**Re: Permit No. M-1980-244; Cripple Creek & Victor Gold Mining Company; Cresson Project;**  
**Technical Revision 140 – Third Adequacy Review Response**

On February 6, 2024, Newmont Corporation's Cripple Creek and Victor Gold Mining Company (CC&V) received the Division of Reclamation, Mining and Safety (DRMS) Third Adequacy Review of Technical Revision (TR) 140 to Permit M-1980-244, regarding the VLF2, Phase 3 Stage A.2 Record of Construction Report. Below are DRMS comments in bold and CC&V's responses in *italics*.

Leak Detection Trench 1  
As-Built

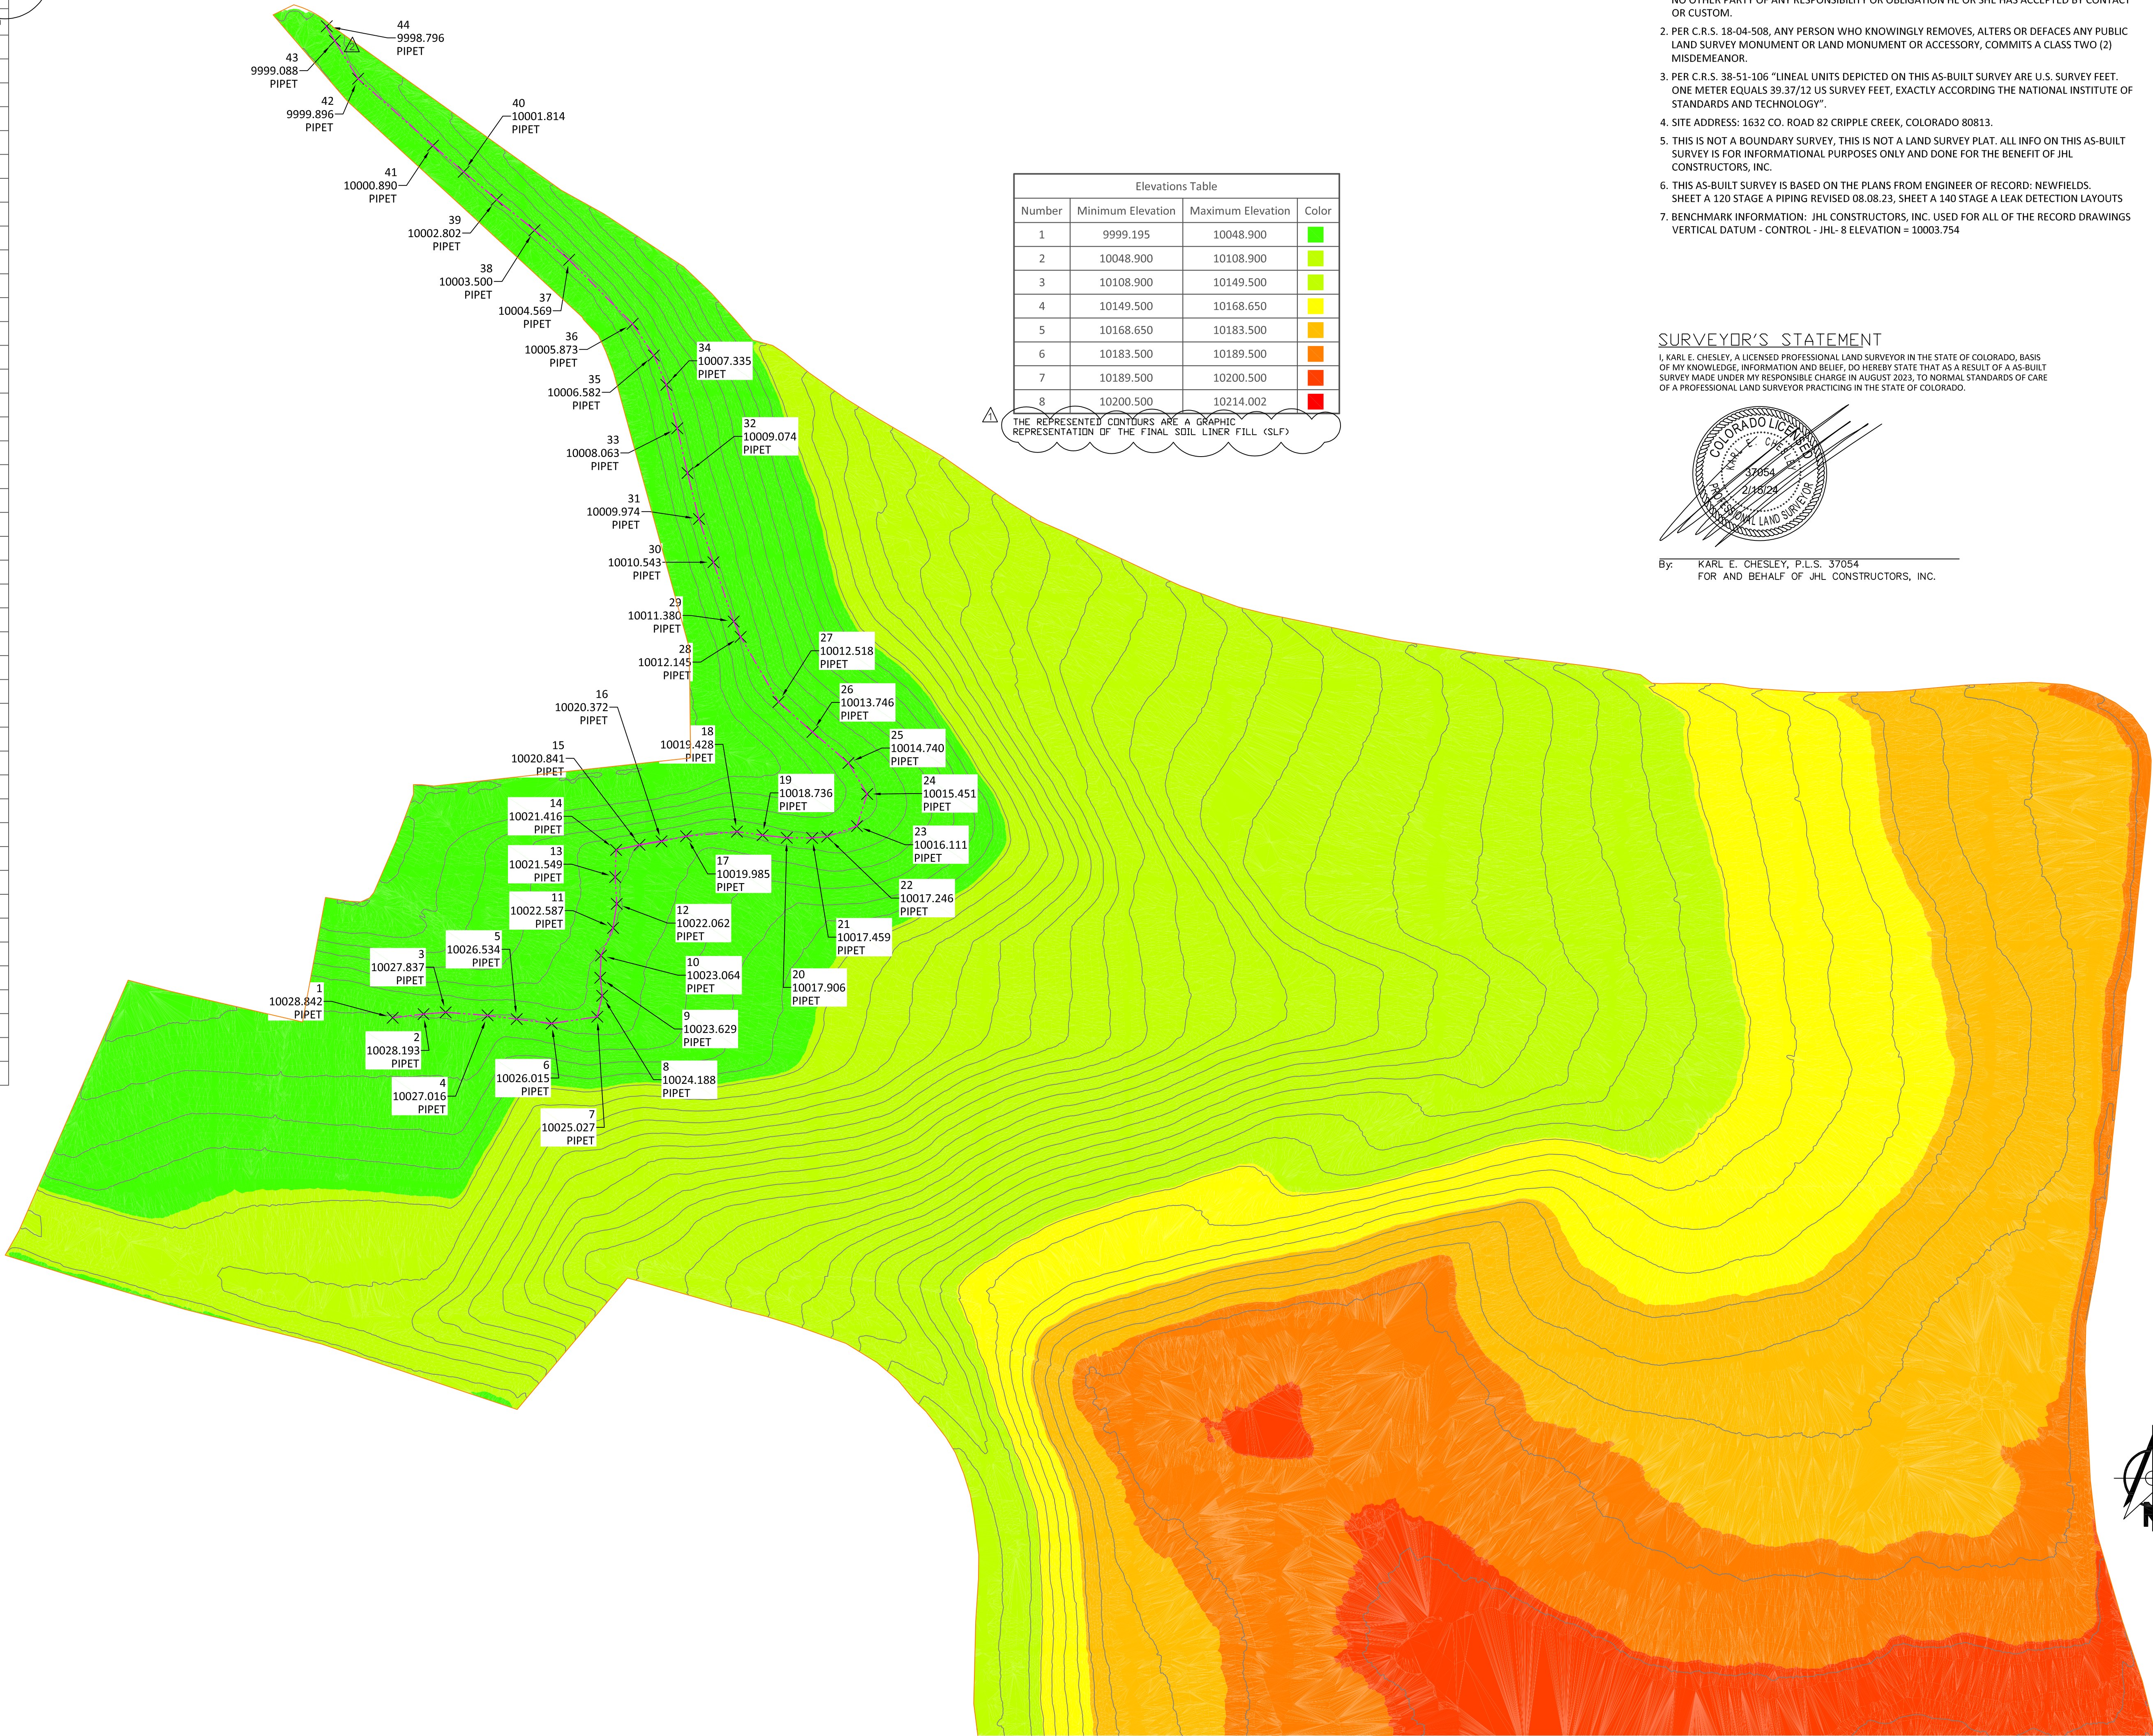
**All horizontal bends must be accounted for, and each of those bends must have a top of pipe elevation to accurately assess the as-constructed grade at which these leak detection pipes were installed.**

**Please see the three examples in Attachment A depicting the unsupported horizontal bends presented in the Leak Detection Trench As-Built drawings. Based on the information received to date there is either additional survey data that has not been reported but supports the existence of the additional horizontal bends in the Record Drawings; or the Record Drawings do not reflect the as-constructed conditions of the Leak Detection System (LDS) piping. Please explain the discrepancy and make the appropriate changes (either submit additional survey data and/or revise the record drawings) and resubmit to the Division.**

*The original drawing was generated to provide a plan view layout and was not intended to display elevation information on all the bends at frequencies shorter than 100 feet. The revised drawings are enclosed as Attachment 1 & 2.*

<b>NewFields</b>		CLIENT <b>CRIPPLE CREEK &amp; VICTOR GOLD MINING COMPANY</b>	
PROJECT		<b>VLF3 PHASE 3 STAGE A.2</b>	
TITLE <b>LEAK DETECTION TRENCH 1 AS-BUILT PLAN AND PROFILE</b>		FILENAME 0106.060.064F	REVISION
		FIGURE NO. <b>5</b>	<b>4</b>

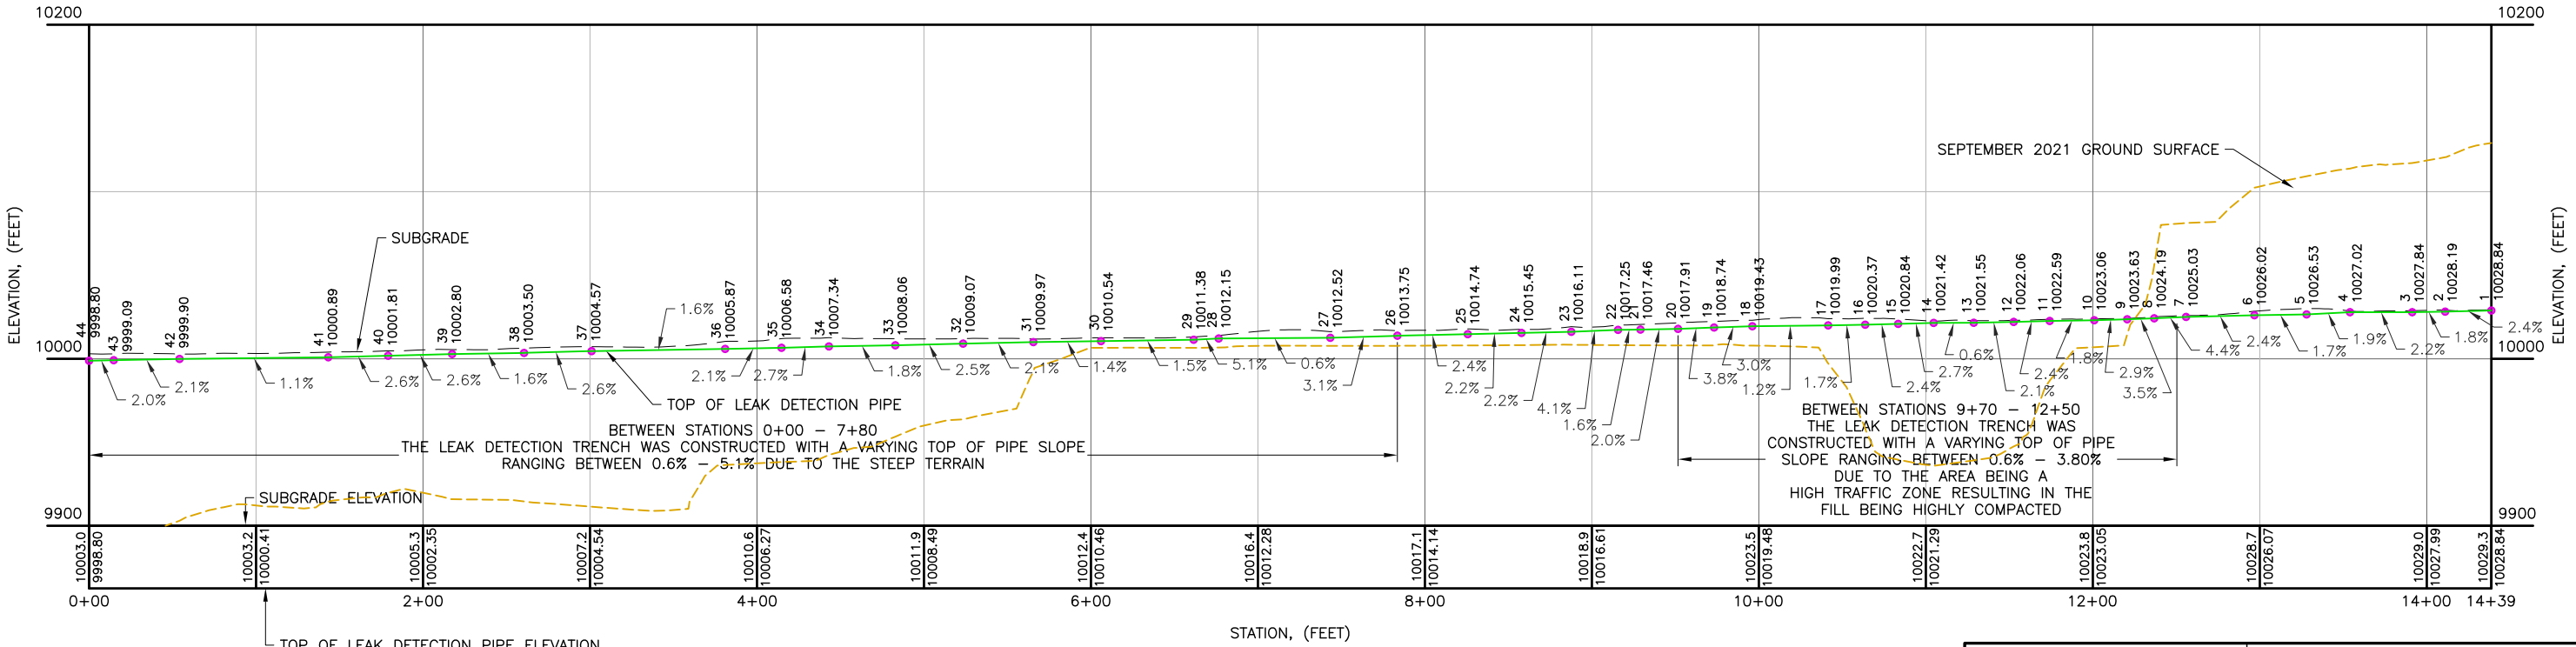
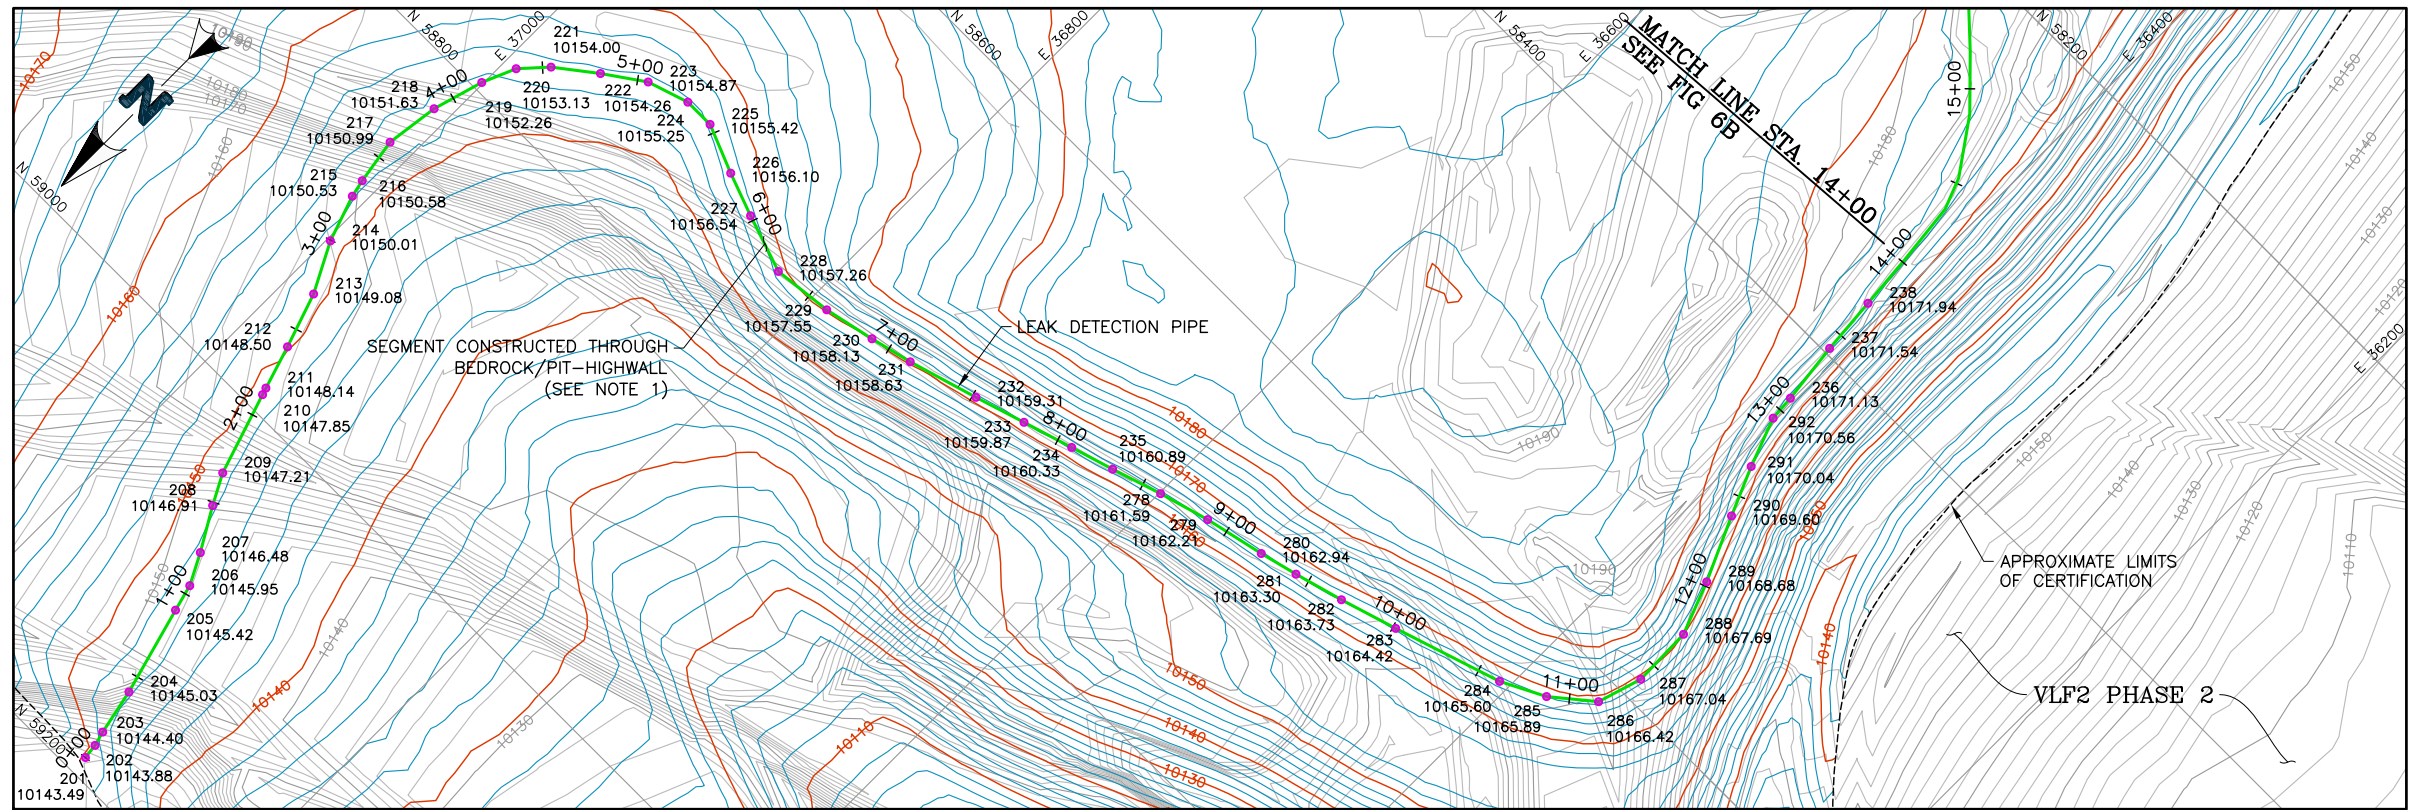
The Division asked for the slope indicator labels to be moved to the profile view as is standard civil engineering practice. Instead, the font size of the slope indicators in the plan view was slightly increased but is still obscured by crisscrossing topography contours. The Division also asked for segments (*i.e., beginning and ending stations; STA X+XX to STA Y+YY*) not meeting the 2% slope criteria and why (e.g., *was constructed at a ZZ% slope due to \_\_\_\_ field conditions*) also be provided in the profile view. None of this information was moved to or expanded upon in the profile view. As such, only incomplete and illegible information has been provided to explain why deviations to the approved drawings and specifications were allowed by the approving engineer. This required information is for the public record. As such it must be thorough and legible. Therefore, as a condition to approving TR-140, the Division is now requiring standard civil engineering practice be followed on Figures 5 and 6 cited in the Deviations section of the CQA report to explain deviations to the approved designs and specifications. This includes the following:

- Slope indicators must be shown in the Profile Views on Figures 5 and 6.
- Beginning and ending stations where the 2% minimum slope was not adhered to, must be identified in the Profile View on Figures 5 and 6.
- The rationale for these segments of the Leak Detection System needing not meet approved drawings and specifications must clearly be directed at these specific segments either by a note with a leader specifying the beginning and ending stations or a note in the Profile View over the specific segments explaining why the approved grades were not met.

*Enclosed as Attachments 3-5, Figures 5, 6a and 6b have been revised to include the location of the survey points, slopes, and an explanation for the reason why the minimum slope of less than 2% was allowed with the corresponding stationing in the profile view as requested.*

- SEGMENT CONSTRUCTED THROUGH STEEP SLOPES MAKING CONSTRUCTION AT EXACT SLOPE PROHIBITIVELY DIFFICULT.
- SEGMENT CONSTRUCTED THROUGH A HIGH TRAFFIC AREA (AUGUST 2021 - JUNE 2023) RESULTING IN A HIGHLY COMPACTED FILL. GIVEN THE LEVEL OF COMPACTION THIS AREA RECEIVED AS A RESULT OF THIS TRAFFIC, SETTLEMENT IS UNLIKELY.
- OVERALL SLOPE OF LOWER LEAK DETECTION TRENCH IS 2.1%.
